In the Matter of: Entergy Nuclear Operations, Inc.  
(Indian Point Nuclear Generating Units 2 and 3)

WCAP-14577 Rev. 1-A  
Project Number 686

Subject: Westinghouse Owners Group  
Transmittal of Approved Version of WOG Aging Management Report,  
"License Renewal Evaluation: Aging Management for Reactor Internals",  
WCAP-14577 Rev. 1-A (MUHP-6110)

**Figure 4-1 Reactor Internals License Renewal Fatigue Evaluation**

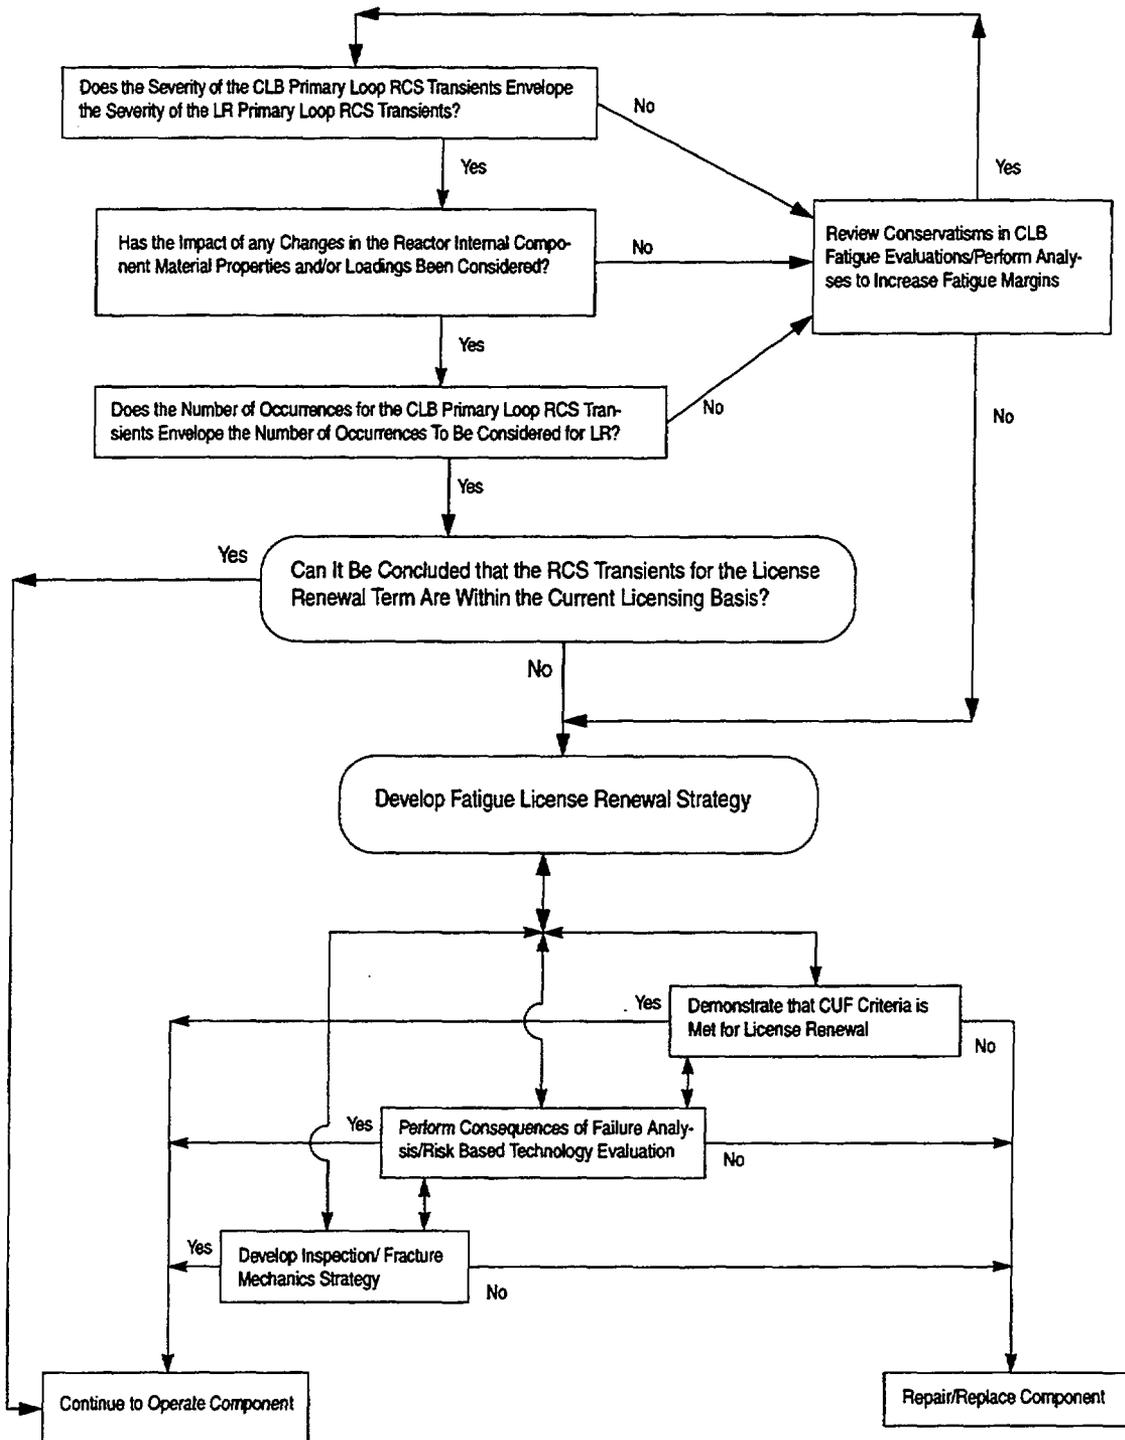
The license renewal application will follow the flowchart in Figure 4-1 of WCAP-14577 to assess the acceptability of the RVI components relative to fatigue for the extended period of operation.

The preferred approach, shown in the first part of Figure 4-1, is to demonstrate that the fatigue effects anticipated for the license renewal term are bounded by the fatigue effects anticipated for the original service period. This includes an assessment of the number and severity of the RCS design transients anticipated during the extended period of operation relative to those assumed to occur in the Current Licensing Basis (CLB), and an assessment of the impact of changes to the reactor internals component material properties that may have occurred during the current licensing period.
